Whipple Consulting Engineers, Inc.

September 14, 2023

**Re: Response to Determination of Incompleteness  
Beard Addition – A Residential Subdivision and PUD**

This letter is to confirm receipt and respond to the determination of incompleteness for the Beard Addition Preliminary Long Plat and PUD, City of Spokane file number Z23-190PPUD. For clarity, City of Spokane and agency comments are listed below and in italic type, and our responses are in roman type (upright).

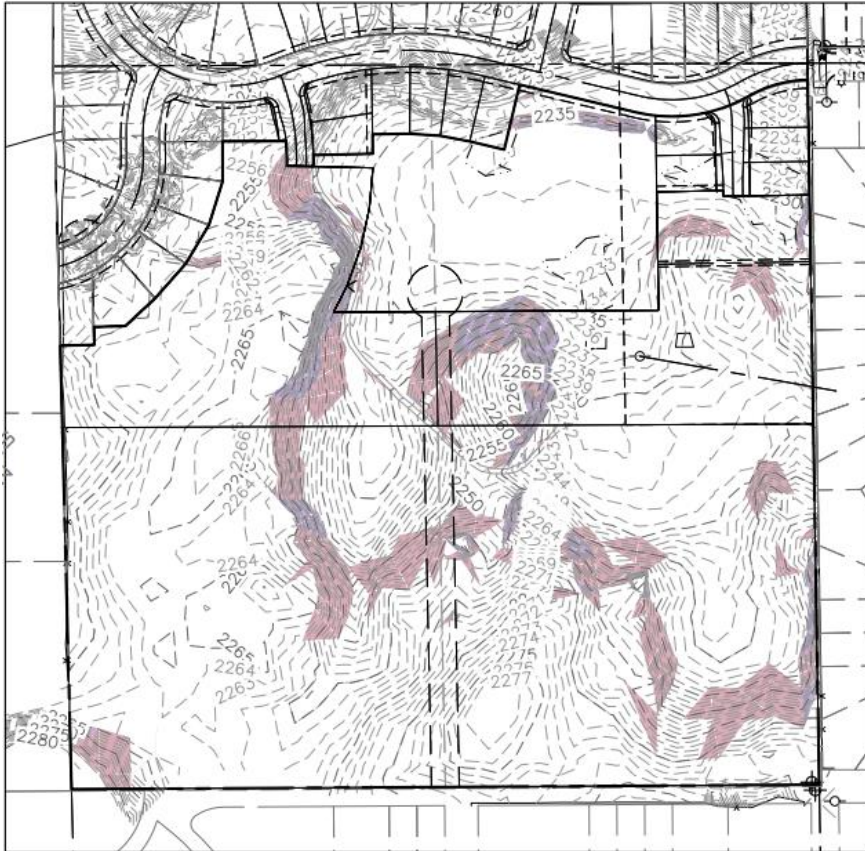
- *Applicant states the project will set aside steep or natural slopes; However, the SEPA checklist, Environment, Earth 1.,e. describes proposed grading will be for the utilities, streets, lots, building pads and storm ponds. The grading would involve removal of organics, preparation of street subgrade and preparation of building pads. This will occur over the entire site. How does removing all the vegetation and grading the entire site preserve steep or natural slopes?*

**WCE Response:** The site will contain grading across the entire site; however, the project sets aside all areas for clearing and grading in the event that utility connections or unforeseen issues occur that will necessitate further clearing or grading. The project will preserve vegetation and slopes in and around the wetland tracts.
